# Access Compliance Report

## Public Rights-of-Way

### (Curb Ramps)

Intersection ID: 29681	Main Street: DARLINGTON_RD	Cross Street: EQUESTRIAN_DR	Location: E
ADA ID: 403BC5BC0034	Ramp Type: PerpDiag	Initial Pass/Fail: Fail	Overall Compliance: No
Severity Score: 22.5			
Codes/Mitigation Info/Possible Solution		Field Measurements/Component Compliance

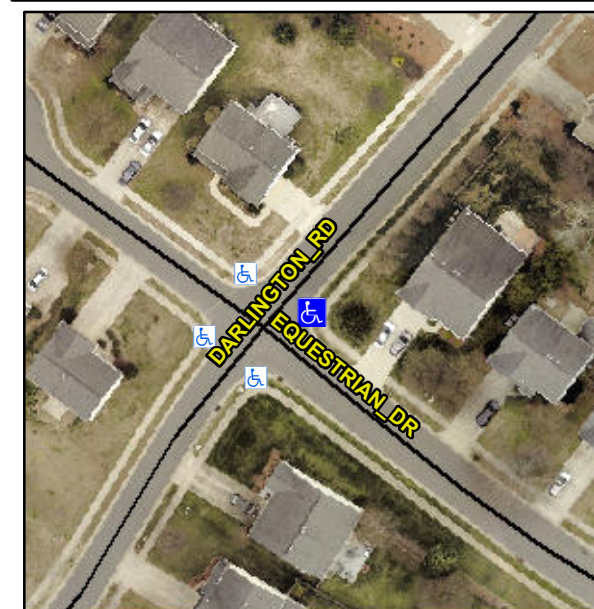
**R304.5.1, R304.2.2, R304.5.3**

**Remove & Replace Curb Ramp With Two New Directional Ramps or Equivalent.**
